CITY OF CODY  
PLANNING, ZONING AND ADJUSTMENT BOARD  
SPECIAL MEETING  
TUESDAY, August 30, 2022  
CITY HALL COUNCIL CHAMBERS @ 12:00 NOON

CITY OF CODY PLANNING, ZONING AND ADJUSTMENT BOARD STAFF REPORT			
<b>MEETING DATE:</b>	AUGUST 30, 2022	<b>TYPE OF ACTION NEEDED</b>	
<b>AGENDA ITEM:</b>		P&Z BOARD APPROVAL:	X
<b>SUBJECT:</b>	REQUEST FOR 9-FOOT-TALL FENCE ALONG SIDE YARD OF 2325 NEWTON AVENUE. FNC 2022-05	RECOMMENDATION TO COUNCIL:	
<b>PREPARED BY:</b>	TODD STOWELL, CITY PLANNER	DISCUSSION ONLY:

<b>MEETING DATE:</b>	AUGUST 30, 2022	<b>TYPE OF ACTION NEEDED</b>	
<b>AGENDA ITEM:</b>		P&Z BOARD APPROVAL:	X
<b>SUBJECT:</b>	SITE PLAN REVIEW: CITY BREW AT 1562 SHERIDAN AVENUE. SPR 2022-10	RECOMMENDATION TO COUNCIL:	
<b>PREPARED BY:</b>	TODD STOWELL, CITY PLANNER	DISCUSSION ONLY:

<b>MEETING DATE:</b>	AUGUST 30, 2022	<b>TYPE OF ACTION NEEDED</b>	
<b>AGENDA ITEM:</b>		P&Z BOARD APPROVAL:	
<b>SUBJECT:</b>	PLAT AMENDMENT— VACATE A 3-LOT SUBDIVISION AND ASSOCIATED EASEMENTS. SUB 2022-06	RECOMMENDATION TO COUNCIL:	X
<b>PREPARED BY:</b>	TODD STOWELL, CITY PLANNER	DISCUSSION ONLY:

**70' Proposed Fence**

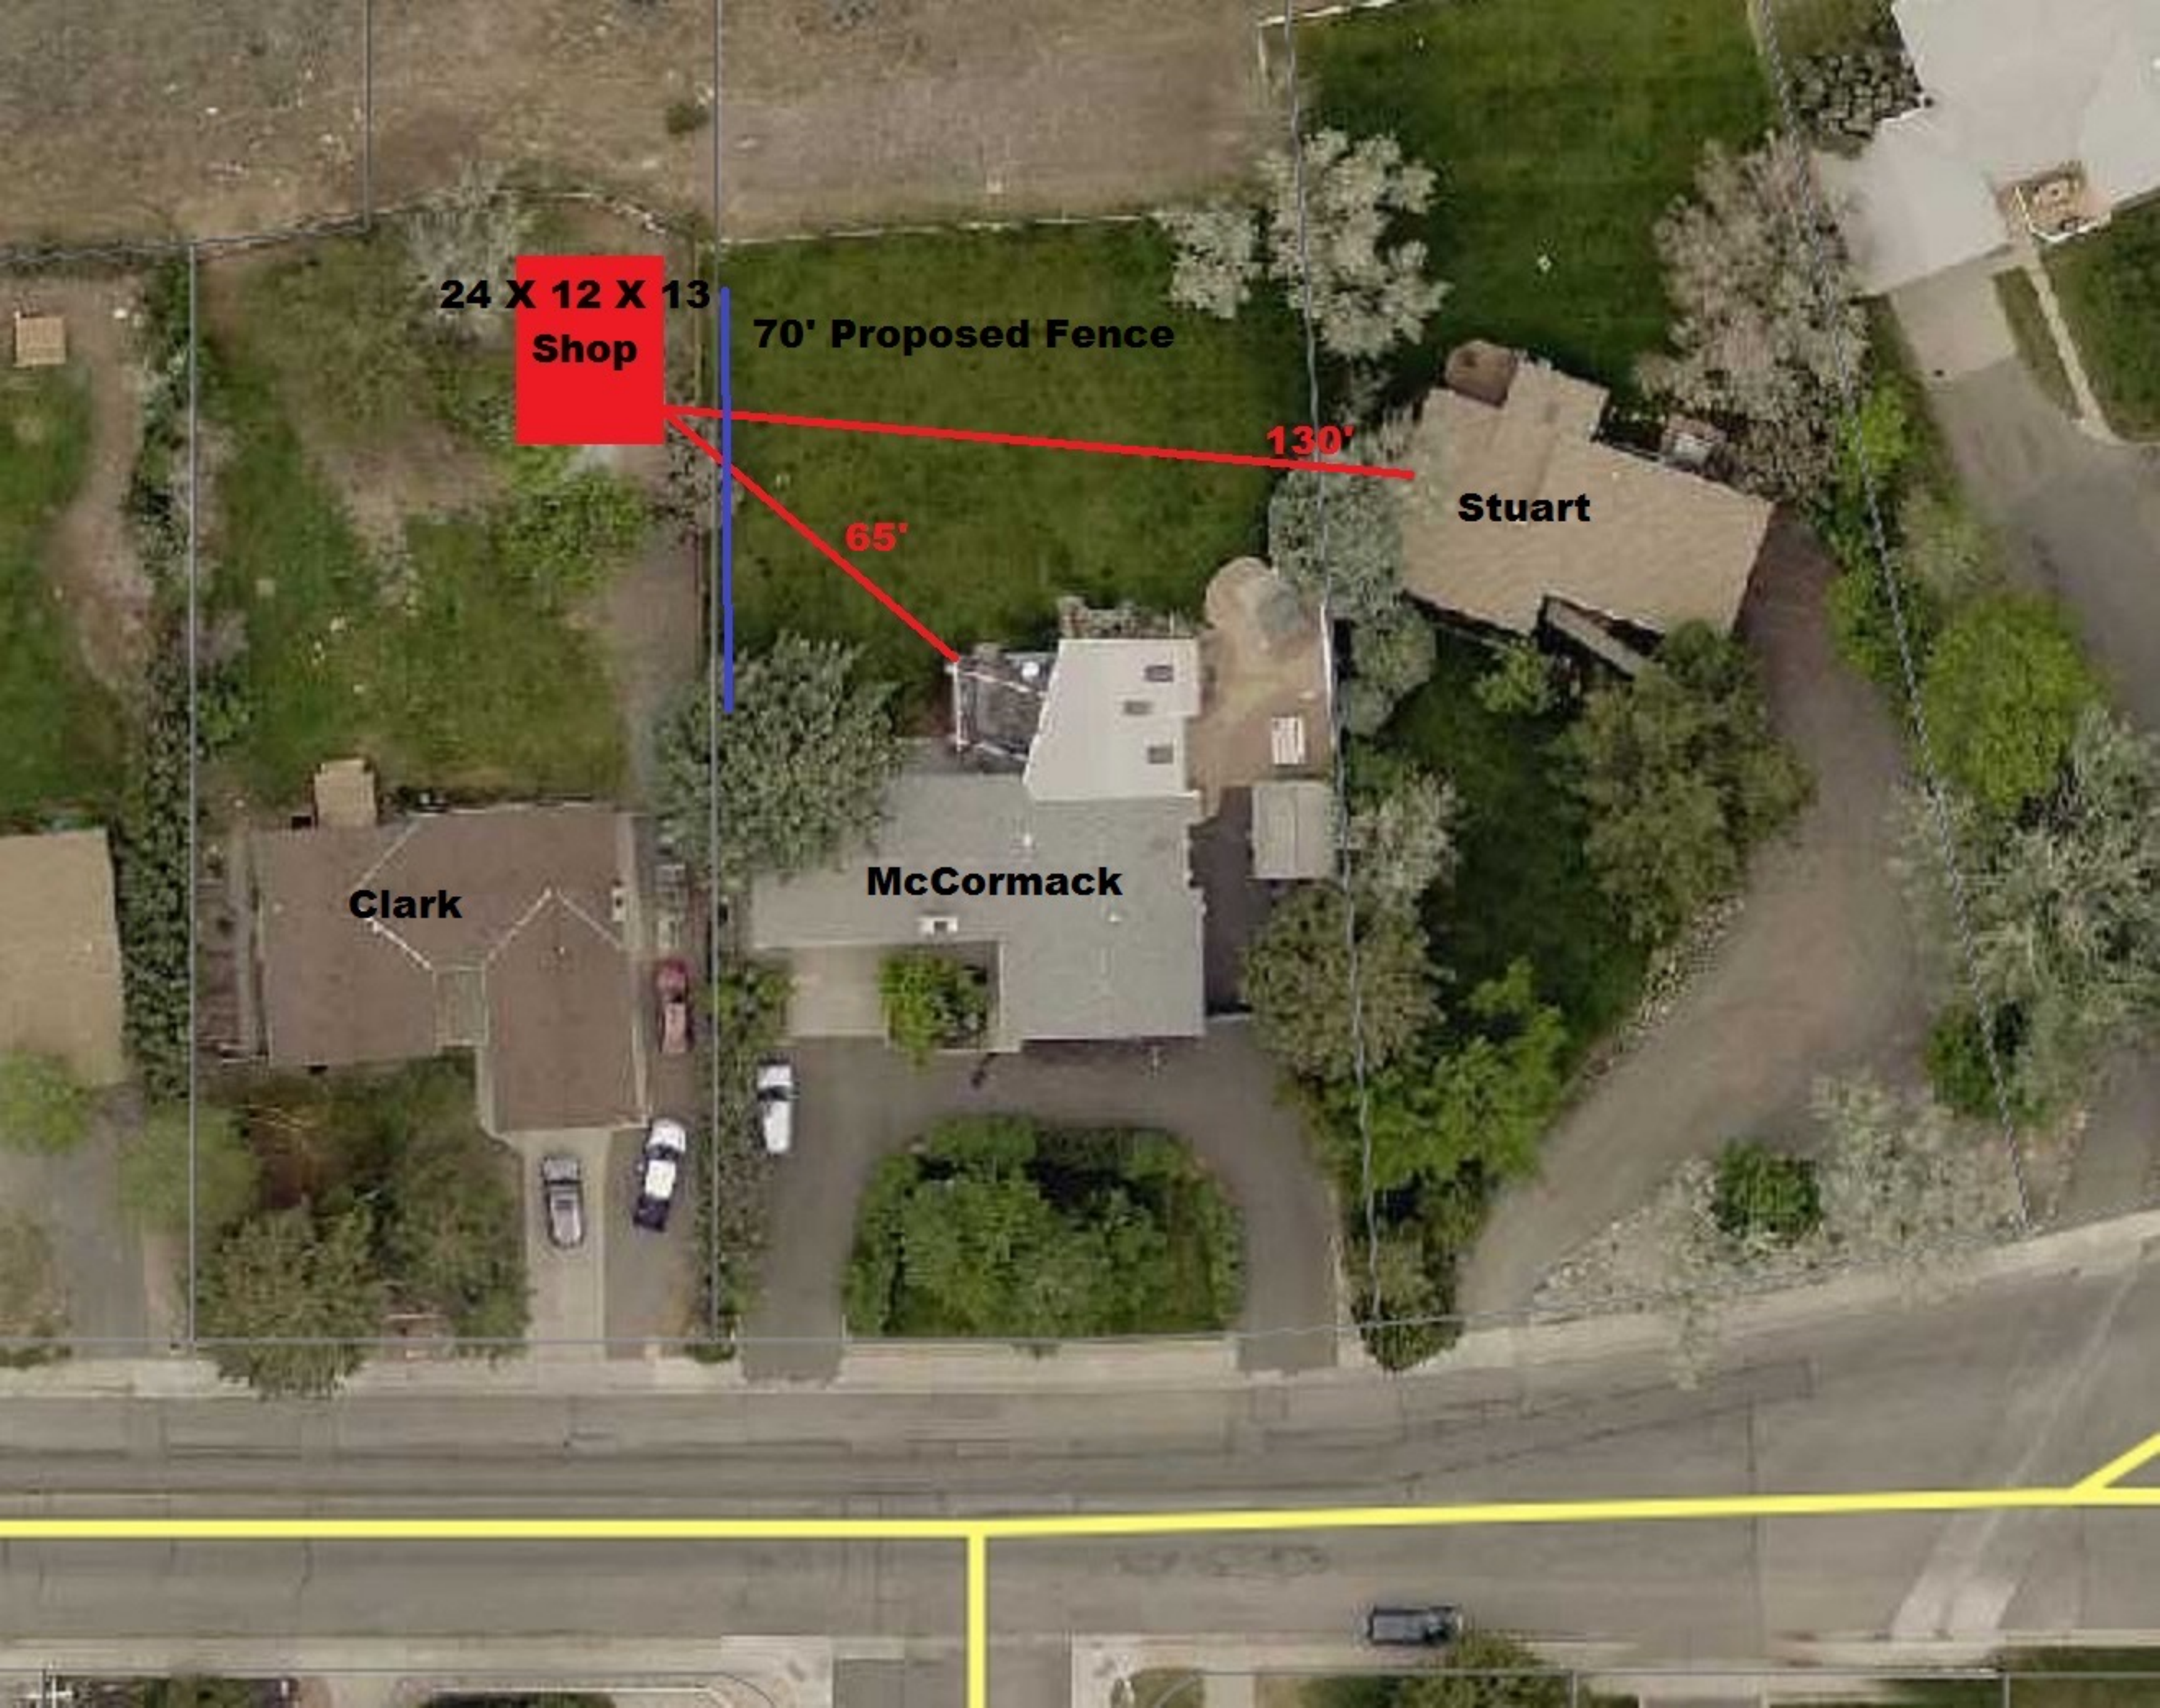
The sketch below shows a black line at the approximate perimeter of a 9-foot-tall fence extending to what would be necessary to screen the metal building from the windows and back decks of the McCormack and Stuart houses. (From an existing stump at the south end and a 4x4 fence post at the north end.)

To allow a fence height waiver further south would provide the McCormack property with slightly more privacy, but would appear to greatly impede the neighbors' view of the McCullough Peaks from their back windows and deck area. For this reason, a height waiver to the south of the area shown above is not supported by staff.

Partially approve the fence height waiver—allow a fence up to nine feet in height along that portion necessary to screen the building from the existing back windows of the McCormack and Stuart residences—as shown in the sketch by staff. (This motion leaves the 7-foot height limit in place for all other portions of the fence—south of the stump.)

## ELECTRICAL SITE PLAN

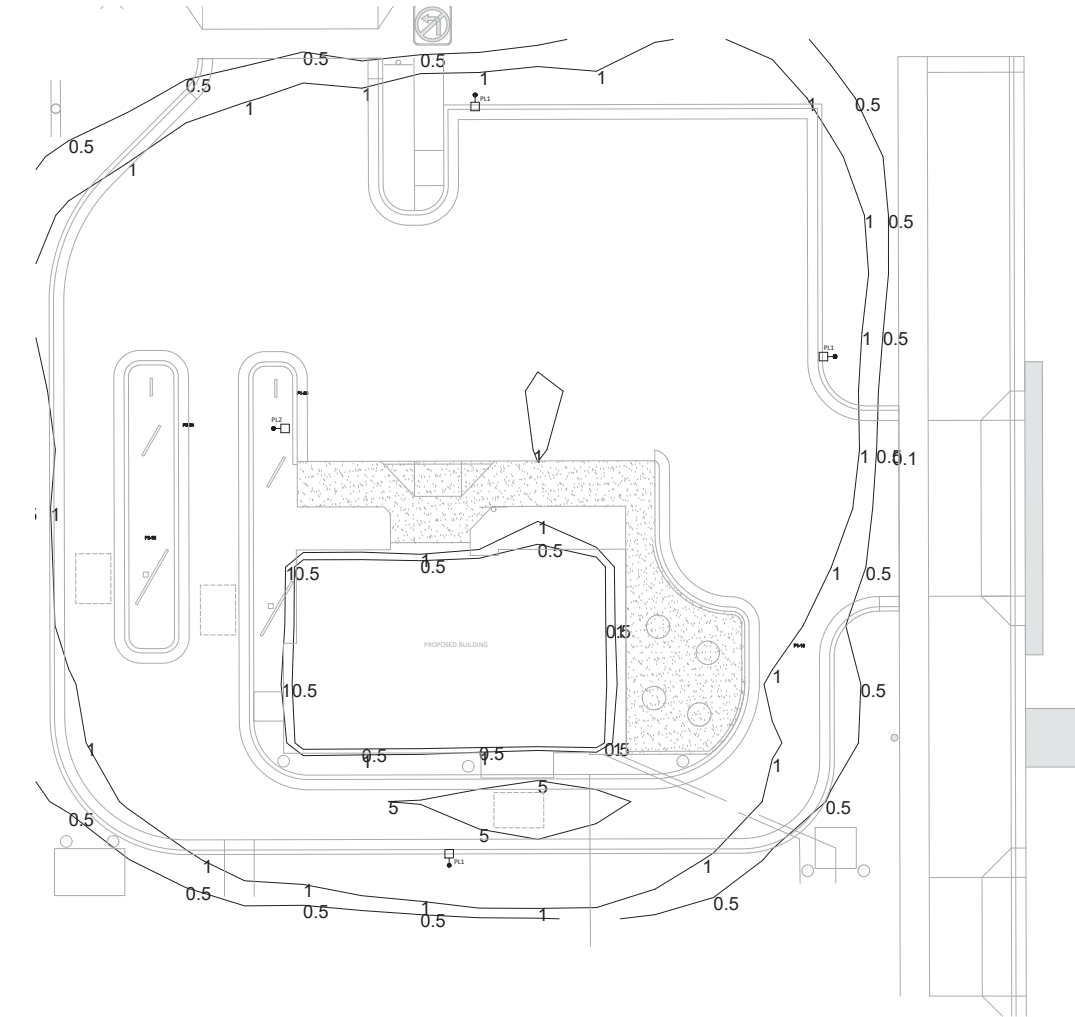
The site plan currently shows a new ground-mounted transformer for the electrical service. Upon consultation with the Electric Division, a pole-mounted transformer gang will be utilized instead. The pole will need to be changed out to accommodate the weight. An estimate has been provided to the developer. The electric division indicates they have all of the materials on hand. The change should be noted on the plans. As there is no longer a need to "hide" the transformer with landscaping, modifications to the number and placement of plants in that area can be proposed.

3. Note the change from utilizing a ground-mounted transformer to the overhead transformer bank on the plans. Modification to the landscaping plan in that area can be proposed.
